Access Compliance Report

Public Rights-of-Way

Intersection ID: 48578	Main Street: PLOTT_RD	Cross Street: MATLEA_CT	Location: NW
ADA ID: 68C9CD886A81	Ramp Type: Perp	Initial Pass/Fail: Fail	Overall Compliance: No
		Severity Score: 10

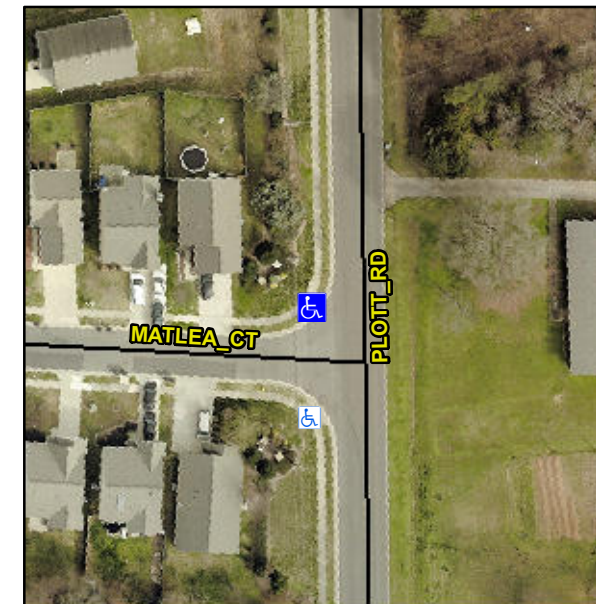
Not Found, R304.5.1, R304.5.3

Compliance	Description	Data	Compliance	Description	Data
N/A	Ramp Length (in)	45.0	Yes	Ramp Slope (%)	5.7
No	Ramp Width (in)	43.5	No	Ramp XSlope (%)	2.3
N/A	Flare Type LT	N/A	N/A	Flare Type RT	N/A
N/A	Flare Slope LT (%)	N/A	N/A	Flare Slope RT (%)	N/A
N/A	Flare Traversable LT?	N/A	N/A	Flare Traversable RT?	N/A
N/A	Landing Length (in)	N/A	N/A	DWS Provided?	N/A
N/A	Landing Width (in)	N/A	N/A	DWS Contrast?	N/A
N/A	Landing Slope (%)	N/A	N/A	DWS Length (in)	N/A
N/A	Landing X Slope (%)	N/A	N/A	DWS Full Width?	N/A
N/A	Landing Curb? (Y/N)	N/A	N/A	DWS Offset (in)	N/A
N/A	Shared Landing?	N/A			
N/A	Gutter Ponding?	N/A	N/A	Gutter Slope (%)	N/A
N/A	Gutter Lip Ht (in)	N/A	N/A	Gutter X Slope (%)	N/A
N/A	Painted X Walk1?	No	N/A	Painted X Walk2?	N/A
	X Walk 1 Direction	To S		X Walk 2 Direction	N/A
N/A	X Walk 1 Width (in)	N/A	N/A	X Walk 2 Width (in)	N/A
	X Walk 1 Slope (%)	1.0		X Walk 2 Slope (%)	N/A
	X Walk 1 X Slope (%)	1.3		X Walk 2 X Slope (%)	N/A

Remove & Replace Entire Ramp.
